To:	City Council
From:	Jeffrey M. Noffsinger, Community Development Director and Historic Preservation Officer
Meeting Date:	October 17, 2026
Re:	Ratification – HPC 26-06 – G3 Casino Resort– Request for Demolition

Staff Report – Amended

To:	Historic Preservation Commission (HPC)
From:	Jeffrey M. Noffsinger, Community Development Director
Meeting Date:	September 22, 2026;
Re:	HPC 26-06 – G3 Casino Resort Request of Demolition
Owner:	G3 Gaming, LLC

GREGORY GULCH GAMING RESORT:
Historic Preservation Plan: Economic & Logistic Consideration

1 **SITE PLAN STRUCTURE 3 - 341 GREGORY STREET**
SCALE: 1/4" = 1'-0" @ 24x36

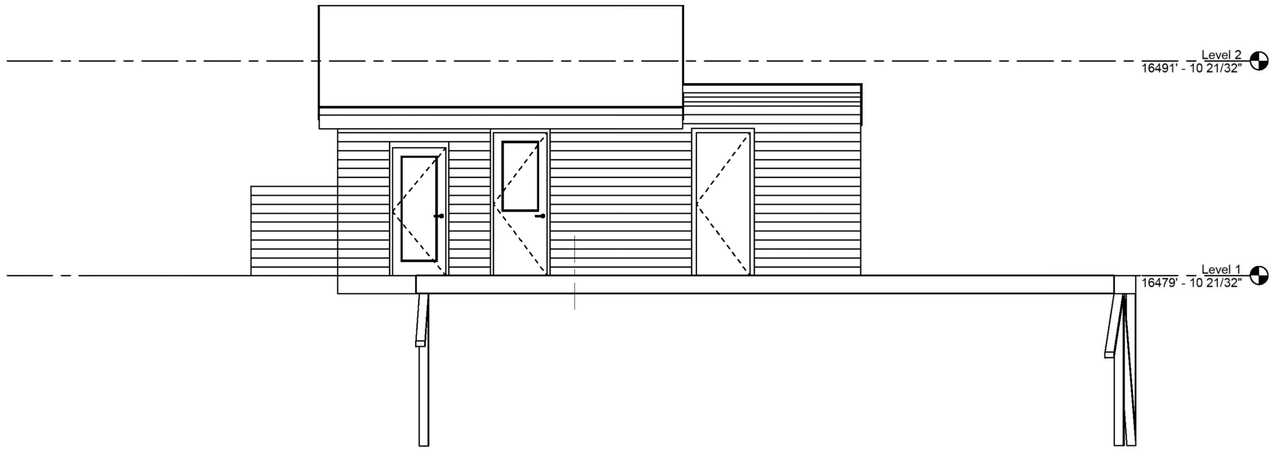
Property #3 – 341 Gregory St – Rock Wall & Accessory Structure
The rock wall does not appear to be original but repaired to look as it was. The accessory structure is not listed on the Survey with the main structure. The applicant is proposing demolish both the rock wall and accessory structure. The rock wall material will be relocated and incorporated into the Historic Discovery Lane. Please refer to Sheet 7.01 and 7.02.

5 SITE PLAN STRUCTURE 5 - 351 GREGORY STREET
SCALE: 1/4" = 1'-0" @ 24x36

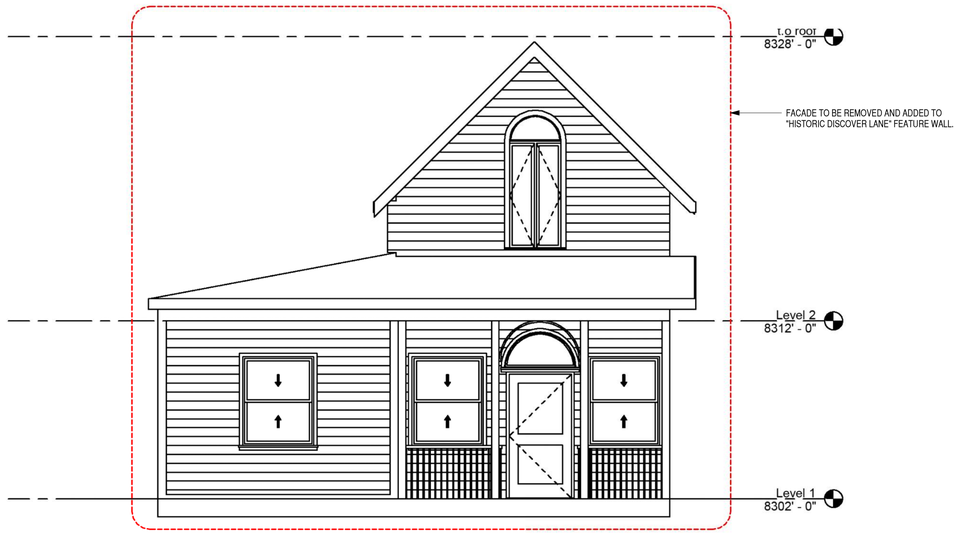
Property #5 – 351 Gregory St
A contributing structure that is proposed to be demolished. The applicant is proposing to remove the front facade and reuse in the Historic Discovery Lane project. The interior is in poor condition with evidence of transient living. As the Historic Preservation Officer, the property is deemed to be unsafe, and it should be removed or relocated as it is an imminent threat to public safety. As such, the requirement for a COA for demolition is waived in accordance with LDC Section 16-2-301(b).

SHEET NUMBER:
HP 6.07

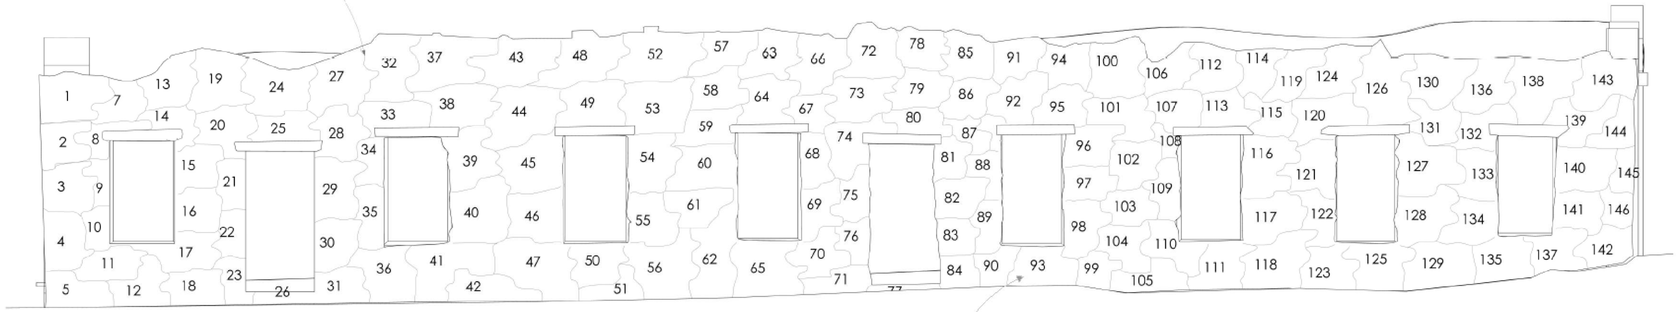
Property #7 – Former Power Plant Ruins
The applicant is proposing to carefully incorporate the north and west facade and relocate into a feature at the Historic Discovery Lane. Please refer to Sheet HP 7.01 for more detail. *The ruins are listed as contributing landmark in the National Historic Landmark District application. The developer is seeking a COA for the removal and relocation of the ruins.*

Property #8 – Freemasons Monument
The applicant is proposing to incorporate the existing Freemason commemorative plaques into the north wall of the Freemasons Plaza. The wall will be constructed from rock materials from the power plant ruins. Please refer to Sheet HP 6.07 and HP 7.01 for more details.

• **Condition 4 (Structural Stabilization of Historic Ruins):** Prior to any structural separation or extraction of the north and west facades of Property #7 (Power Plant Ruins), a licensed structural engineer specializing in historic masonry shall design and execute an on-site temporary shoring and bracing system. This system must fully protect the physical integrity of the ruins during extraction and prevent unapproved structural collapse.

Prior to any structural separation or extraction of the north and west facades of Property #7 (Power Plant Ruins), a licensed structural engineer specializing in historic masonry shall design and execute an on-site temporary shoring and bracing system. This system must fully protect the physical integrity of the ruins during extraction and prevent unapproved structural collapse.

Prior to any structural separation or extraction of the north and west facades of Property #7 (Power Plant Ruins), a licensed structural engineer **shall assist the builder in developing measures necessary to protect the physical integrity of the ruins during extraction and prevent unapproved structural collapse.**

1 **SITE PLAN STRUCTURE 9 - 331 GREGORY STREET**
SCALE: 1/4" = 1'-0" @ 24x36

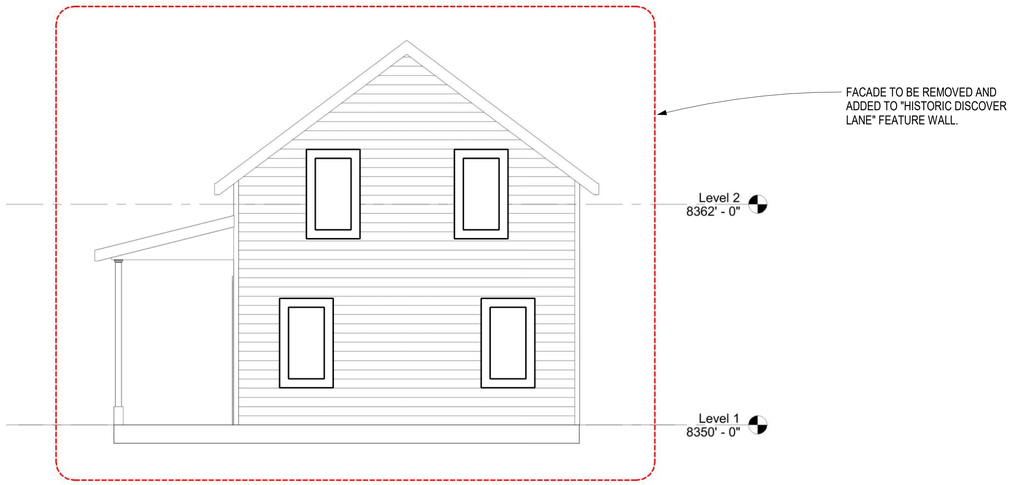
Property #9 – 331 Gregory St
A contributing structure that is proposed to be demolished. The applicant is proposing to remove the west facade and reuse in the Historic Discovery Lane project. The interior is in poor condition with evidence of transient living. As the Historic Preservation Officer, the property is deemed to be unsafe, and it should be removed or relocated as it is an imminent threat to public safety. As such, the requirement for a COA for demolition is waived in accordance with LDC Section 16-2-301(b).
